**Technical Service BULLETIN**

Title: **NOISE FROM TOP OF DASH**  
Models: '01 - '02 RAV4

NVAH  
REVISED  
NV013-01

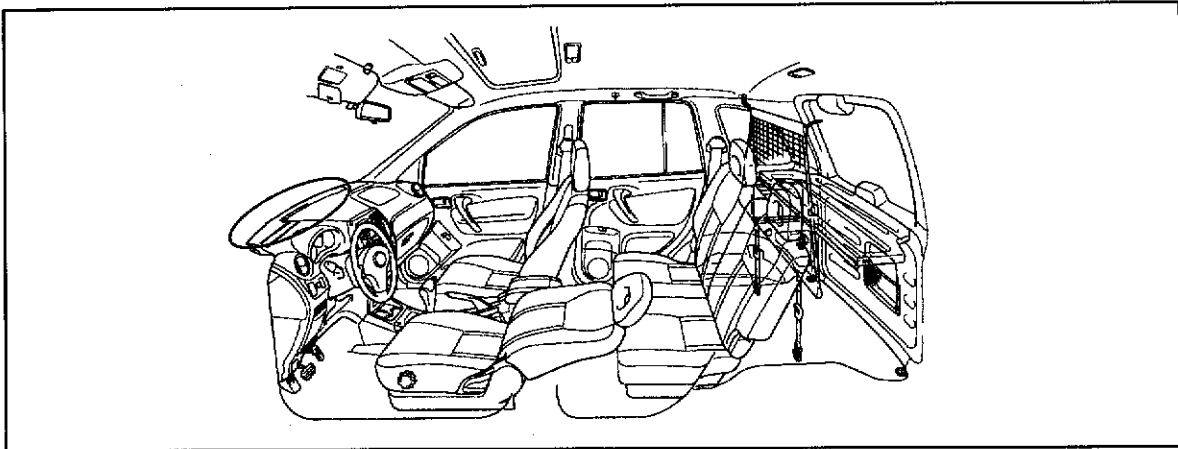
1. Remove the defroster nozzle as explained on pages BO-86 to BO-95 of the 2001 RAV4 Repair Manual Volume 2.
2. Pre-cut strips found in the referenced noise kit are already cut to size for this application.
  - Length: 600 mm
  - Width: 5 mm
  - Thickness: 0.5 mm

3. Apply the felt as shown below and reassemble the instrument panel.
